Wilson Walk
208/210, 220, 230,
240 Wilson Street

CURRENT ISSUE
May 14, 2019

List of Plan changes		
Revision	Page	
1	A01	added keypad for guest entry to access 1 guest parking stall below
2	A01	area of parkade that will be above existing grade is now noted in grey. Parkade will be entirely below finished grade
3	A01	unit numbers changed to account for bachelor units being sold as separate strata unit. This has been shown to be more favourable to council
4	A01	See civil drawings for change in driveway as well as detail 3 on A18. drive aisle held to 8% in order to confirm to parking bylaw.
5	A01	Project site data table updated: 1)added site coverage including parkade above original grade, 2)bachelor suites have been separated out to have their own unit number as they are proposed as separate strata units now. The are below 1.8m so the square footage is not calculated in the FSR.
6	A07	All perspectives have been updated with more realistic and suitable trees and plantings. Please see civil for all road and sidewalk details/ curb cuts, etc.

A18
2 record of plan changes from march 14, 2019

A17 Average Grade Calculation Points

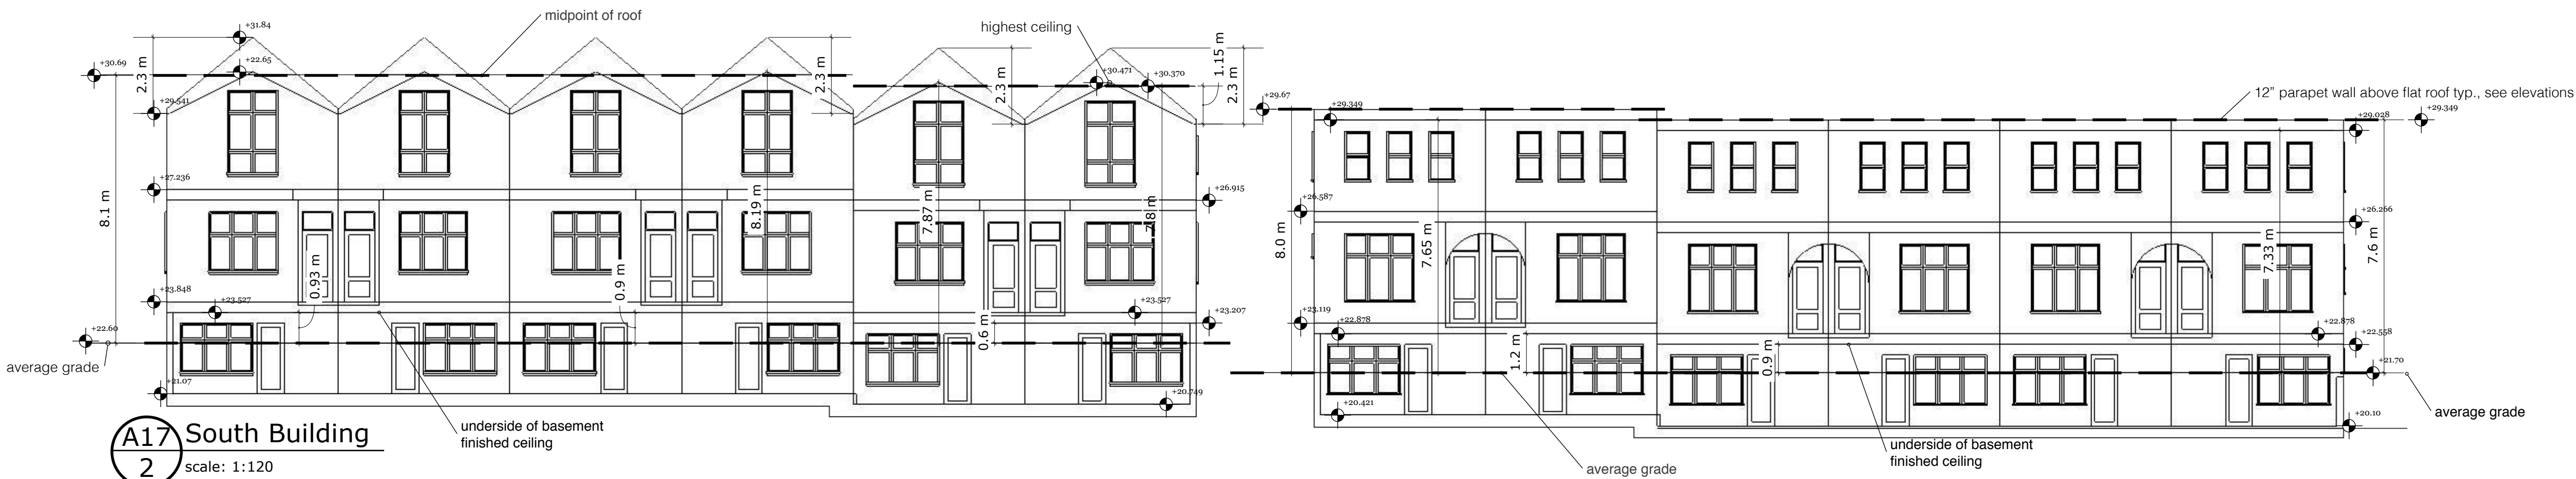
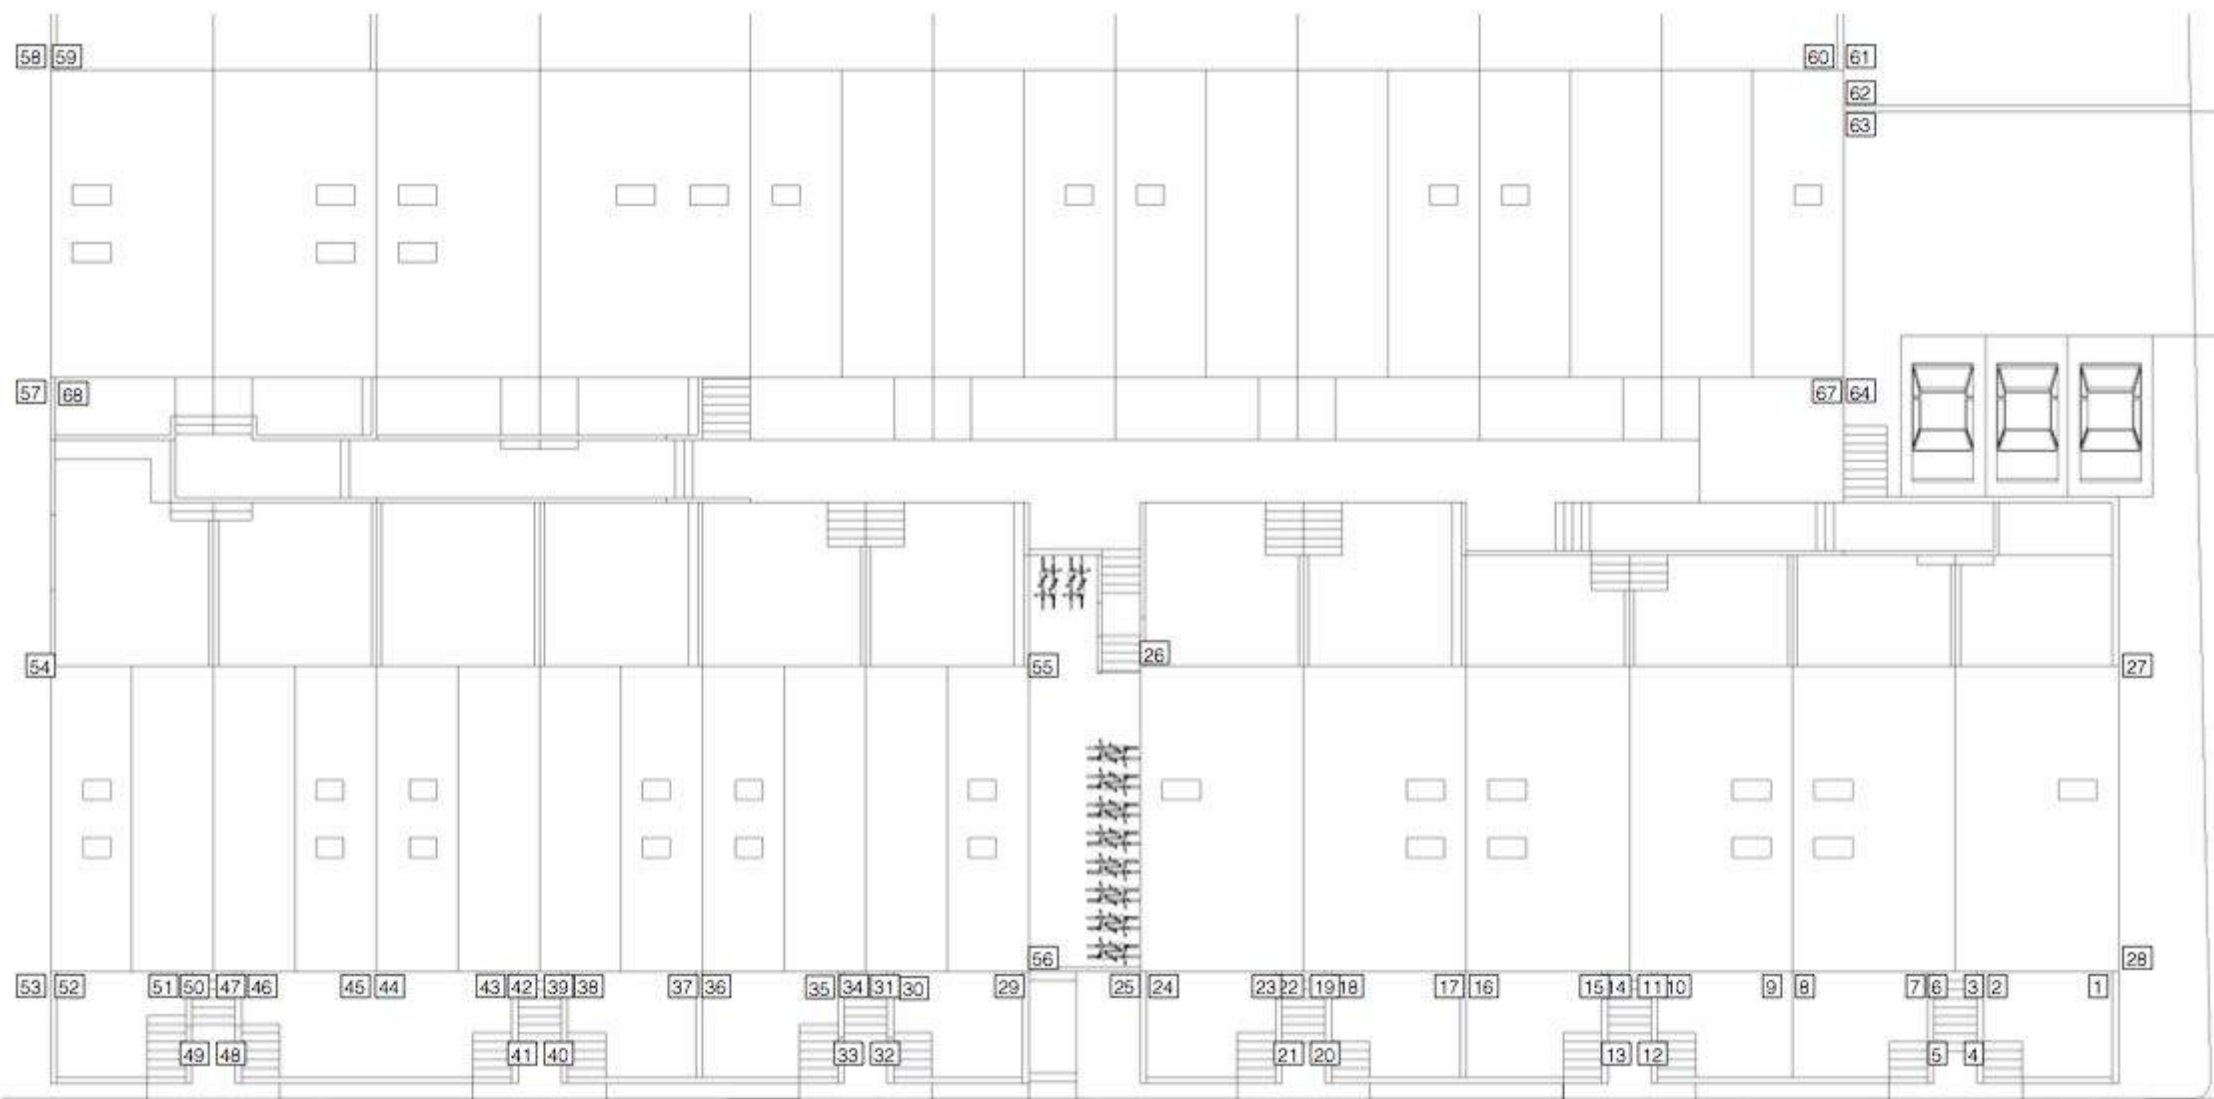
12	A12	roof pitch was changed from 12:12 to 10:12 to keep height of building consistent from what was shown previously given the requirement to raise both the main and upper floors to create better parkade headroom clearance at entry door.
13	A17	changes to height calculations and floor elevations as per above revisions 10 & 11
14	A18	Detail 3 was updated to show how we are complying with drive aisle slope % max as per parking bylaw.
15	A20	dimensions were added in parkade cross sections to better show that we are meeting our 2.1m height clearance requirement. The engineers and architect are well aware of the head clearance requirements and we are and conforming.
16	A22	added detail for front entry stairs from south building leading to sidewalk on Wilson as per feedback from ADP review. Spindle change, dimensions, profiled top cap, return at bottom of stairs and eased transitions.
